Illinois Department of Transportation

SUBJECT: Lake in the Hills Airport
Lake in the Hills, Illinois
McHenry County
Illinois Project Number: 3CK-5001
SBG Project Number: 3-17-SBGP-TBD
Contract No. LK016
Item No. 04A, November 7, 2025 Letting
Addendum A

NOTICE TO PROSPECTIVE BIDDERS

REPLACE AUTOMATED WEATHER OBSERVATION SYSTEM

**SITE PLAN
AND PROJECT
CONTROL PLAN**

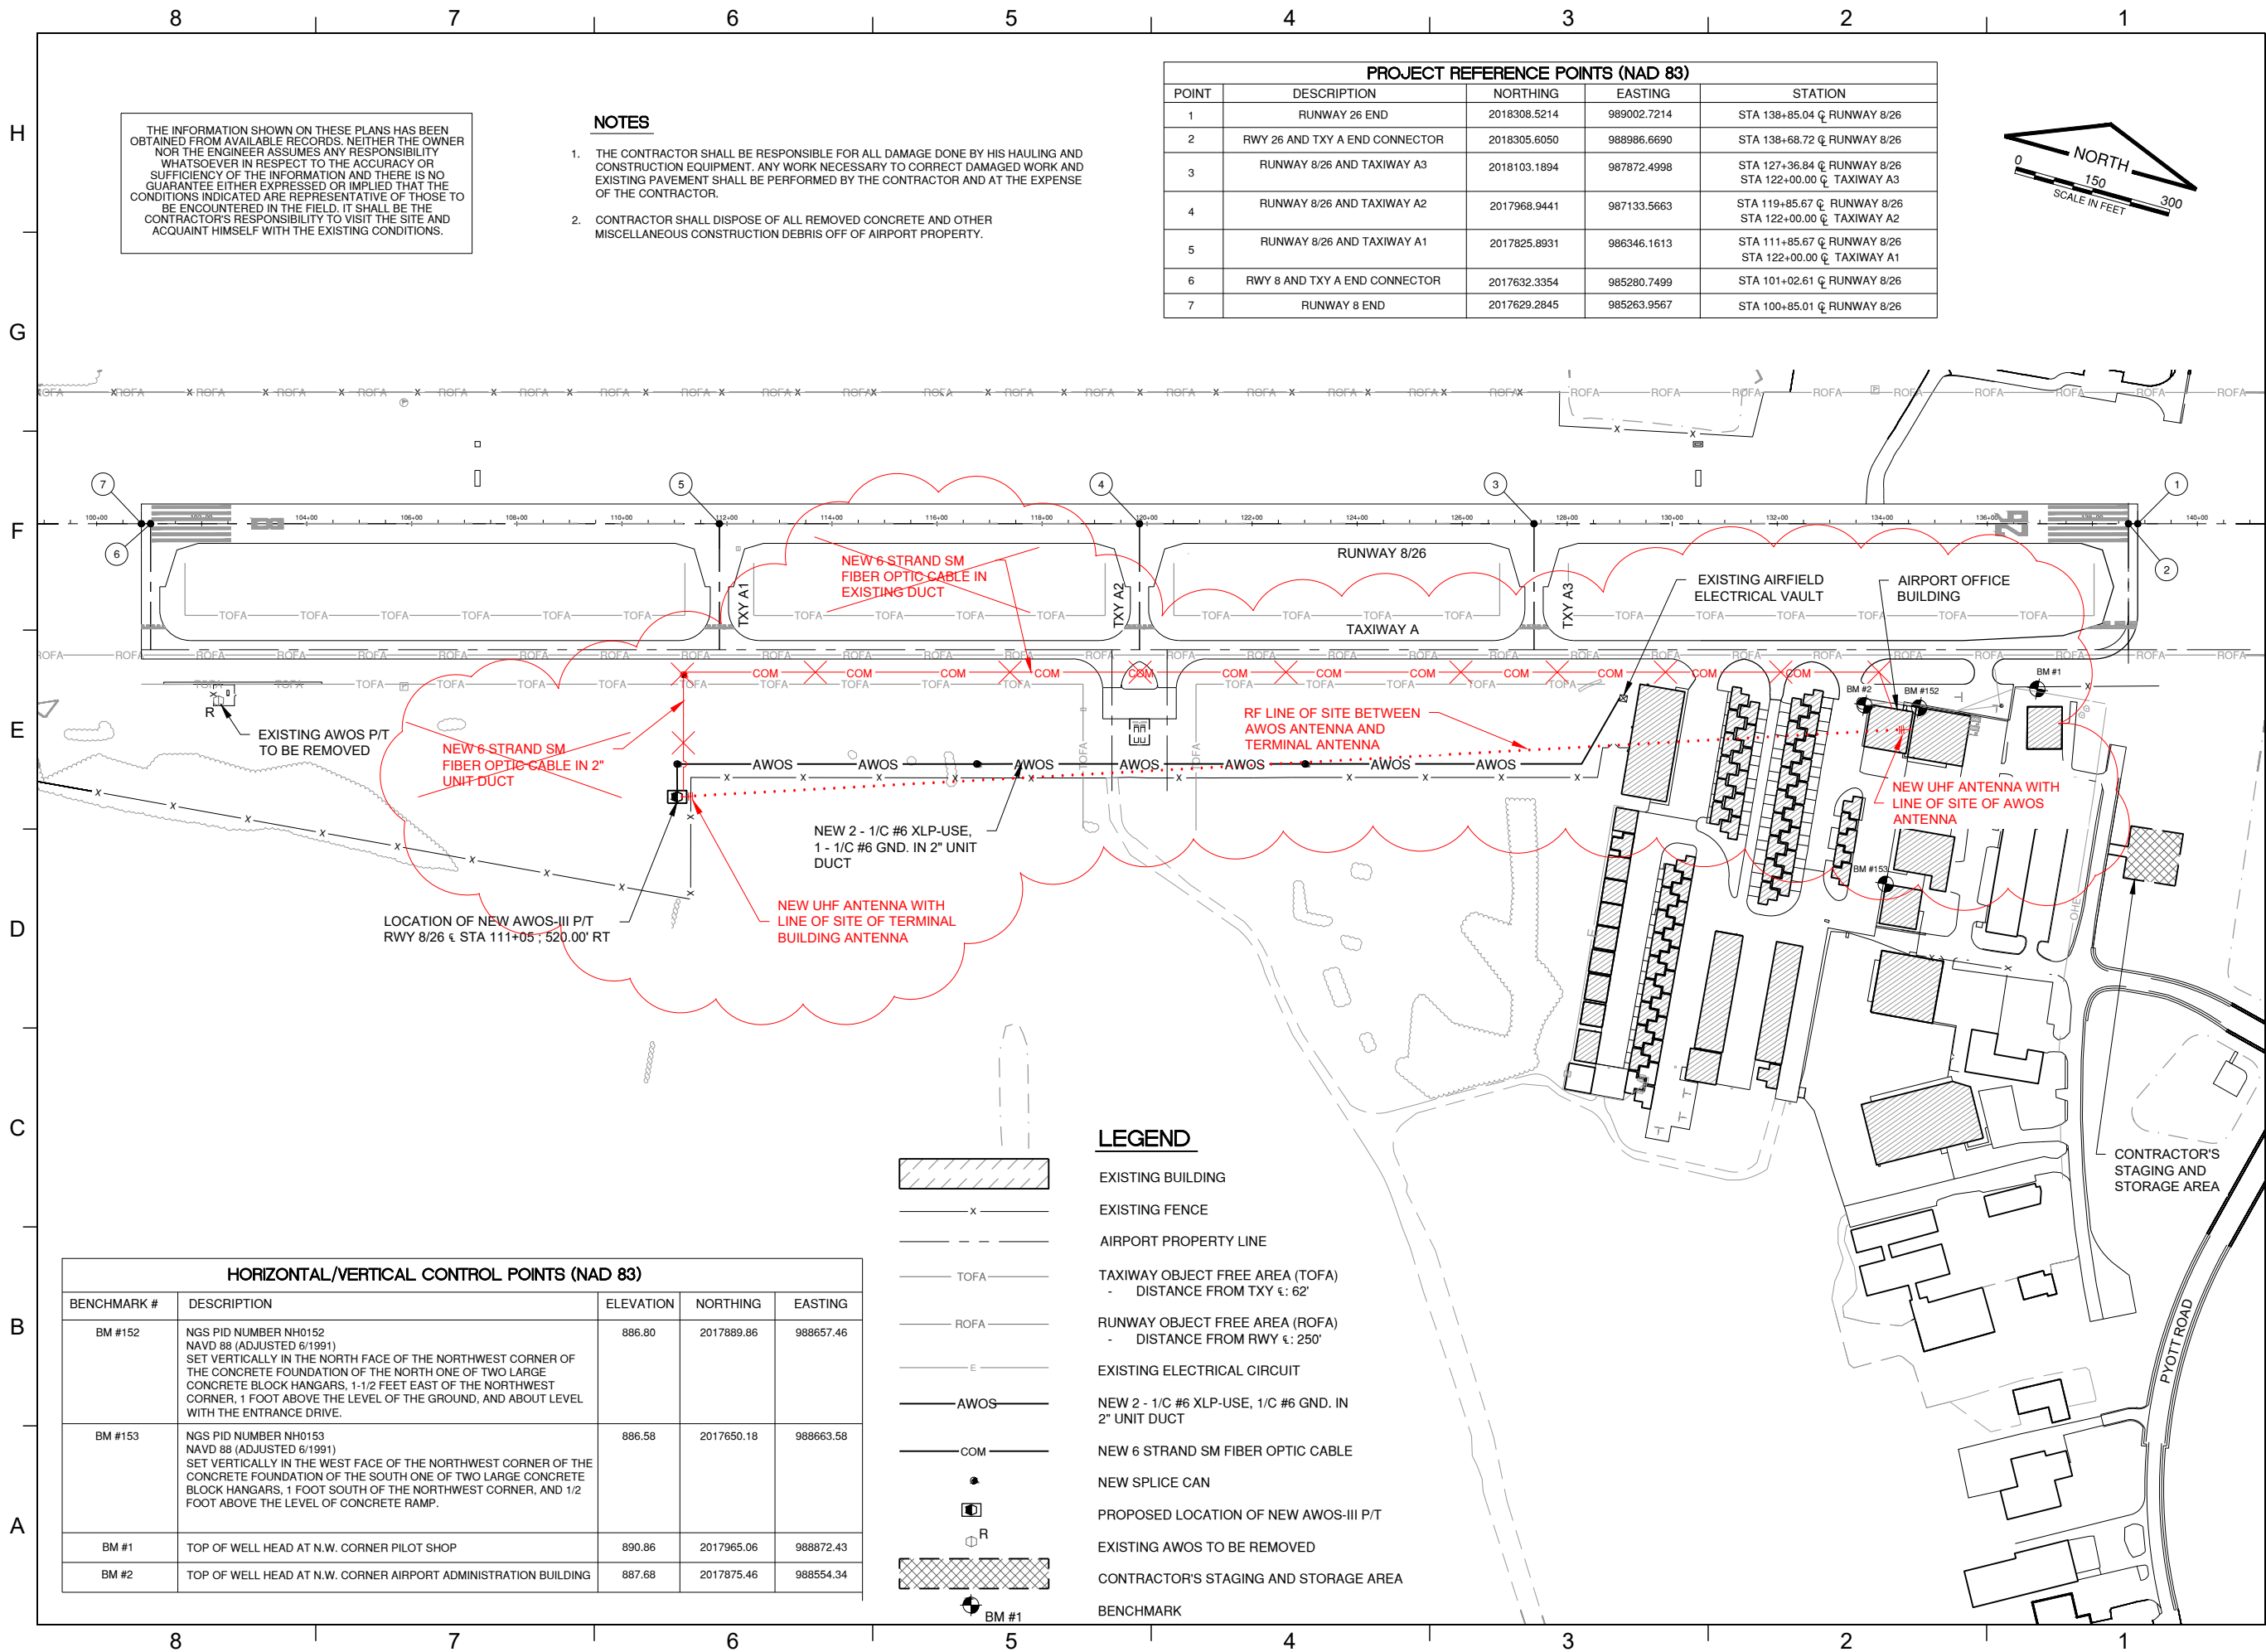
1. Sheet 1 – Cover Sheet
 - a. Summary of Quantities table – Delete AR110215 2" PVC Conduit, Direct Burial and Delete AR800178 Fiber Optic Cable.
2. Sheet 2 – Site Plan and Project Control Plan
 - a. Remove Fiber Optic Cable, add UHF antenna.
3. Sheet 3 – Sequence of Construction Plan
 - a. Remove Fiber Optic Cable, add UHF antenna.
 - b. Delete Work Areas 2A and 2B.
4. Sheet 5 – Sequence of Construction - Details
 - a. Revise construction point table.
5. Sheet 6 – Proposed Improvements – 1
 - a. Remove Fiber Optic Cable, add UHF antenna.
 - b. Delete AWOS Note 7.
 - c. Revise AWOS Notes 4, 5, and 6.
6. Sheet 7 – Proposed Improvements – 2
 - a. Remove Fiber Optic Cable, add UHF antenna.
7. Sheet 8 – Erosion Control Plan
 - a. Revise new seeding (901) and heavy-duty hydraulic mulch (908) limits.
8. Sheet 9 – AWOS Details
 - a. Remove Fiber Optic Cable, add UHF antenna.
